**Safety Evaluation Report for  
SARP 9975 Addendum, Shipment of MOX in Plastic Bottles  
in Model 9975 Packaging, S-SARA-G-00015, Revision 3**

**Docket No. 13-29-9975**

Figure 1.1 9975 Packaging 3-Dimensional Section View

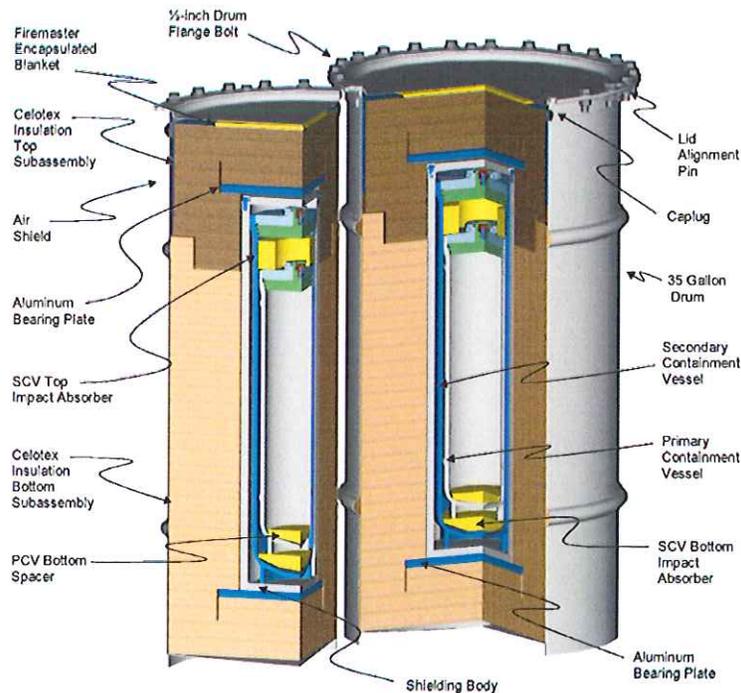
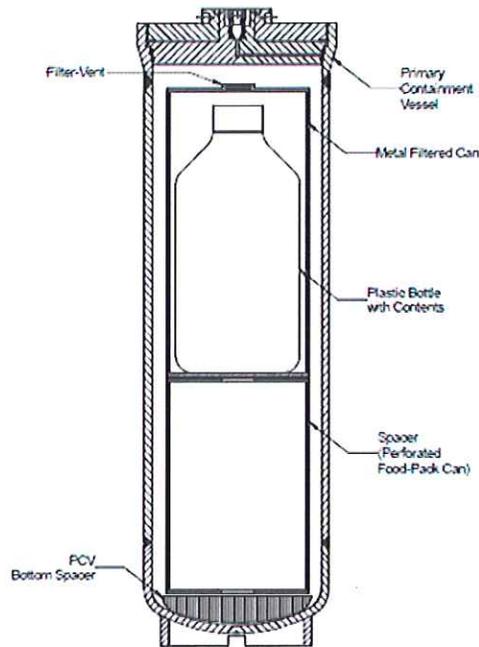
Detailed packaging descriptions and drawings of the package can be found in the 9975 SARP.<sup>3</sup> The components of the 9975 packaging include a 35-gallon drum assembly, impact-limiting and thermal-insulating material Celotex, a Secondary Containment Vessel (SCV), a PCV, and the content containers. The 9975 packaging assembly is shown in Figure 1.1 and in Drawing R-R2-F-0026 of Appendix 1.1 of the SARP.

The PCV is fitted with an aluminum sleeve to fill the space between food-pack cans and the inner wall of the PCV, as illustrated in Figure 1.5 of the SARP.<sup>3</sup> For configurations containing plastic bottles, the PCV sleeve is not analyzed in the gas generation calculation. The PCV sleeve is to restrict the radial run-up length to avoid the deflagration to detonation transition (DDT).<sup>3</sup> For the shipment of MOX in plastic bottles, there will be no DDT due to nitrogen inerting so the PCV sleeve will not be used for the shipments.
